**WATTS BAR NUCLEAR PLANT (WBN) UNIT 1 - TECHNICAL SPECIFICATION (TS)
CHANGE NO. 98-014 - ICE BED FLOW BLOCKAGE SURVEILLANCE REQUIREMENT
3.6.11.4 - RESPONSE TO NRC REQUEST FOR ADDITIONAL INFORMATION (RAI)**

Reference: NRC letter to TVA dated November 18, 1999, "Request for
Additional Information on Clarification of Ice Condenser
Flow Channel Inspection Requirements (TAC NO. MA4295)"

TVA Responses to NRC Request for Additional Information on Clarification of Ice Condenser Flow Channel Inspection Requirements (TAC NO. MA4295)

FLOW PASSAGE NUMBERING SEQUENCE

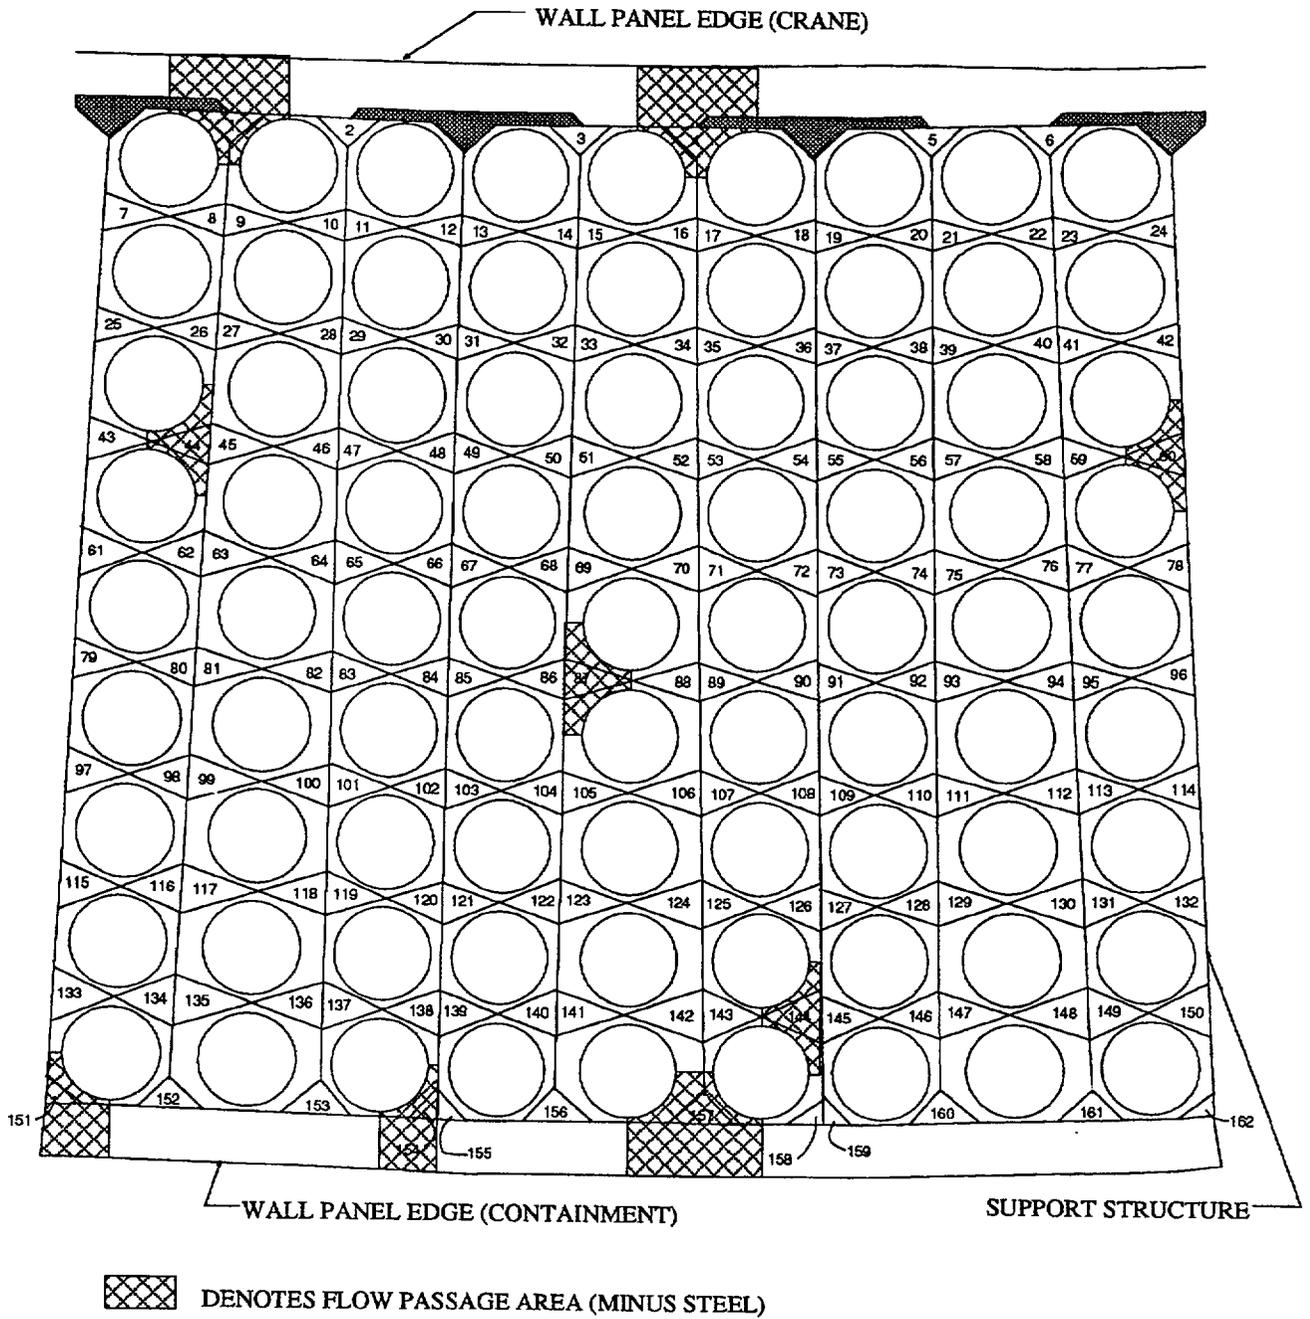
- a. Provide a sketch to illustrate the above flow model showing the flow channels, bays, and sections, explain why "the individual bays are acceptable with greater than 15 percent blockage," and justify the conservatism of the model without using the most restrictive flow area for all the bays in a section to determine the flow area for the model.*
- b. The safety analysis was performed assuming 15 percent blockage for any section. However, the surveillance requirements will be performed in terms of 15 percent of "total flow area," not "for any section." Justify the differences.*
- c. Given the potential for human error in judging the amount of a blockage and perhaps some frost hardening to ice during a cycle, justify allowing an acceptance criterion with no margin to the analysis assumption of 15 percent blockage.*

Enclosure 2 provides a sketch of the flow channels for any given bay, and a sketch of the TMD bays/sections. See also WBN FSAR Figure 6.7-46.

The Transient Mass Distribution (TMD) model lumped the 24 ice condenser bays into six nodes, where nodes 1 through 6 consisted of 2.75 bays, 3.25 bays, 6.5 bays, 4.5 bays, 3.5 bays, and 3.5 bays, respectively. As this is a nodal analysis lumping several bays per node, a detailed flow channel analysis cannot be performed. However, a conservative Watts Bar specific subcompartment pressurization analysis using the TMD model was performed by Westinghouse, and demonstrated that 15 percent effective flow blockage was acceptable. This analysis used experimentally determined loss coefficients for flow through the ice condenser flow paths. The corresponding average flow area employed in the analysis was assumed to be 85 percent of the total flow area (15 percent blockage assumption) which occurs at a lattice frame elevation. This limiting flow area was assumed to be uniform along the flow passage length, and throughout the ice condenser bays. This reduced flow area was assumed to be permanent
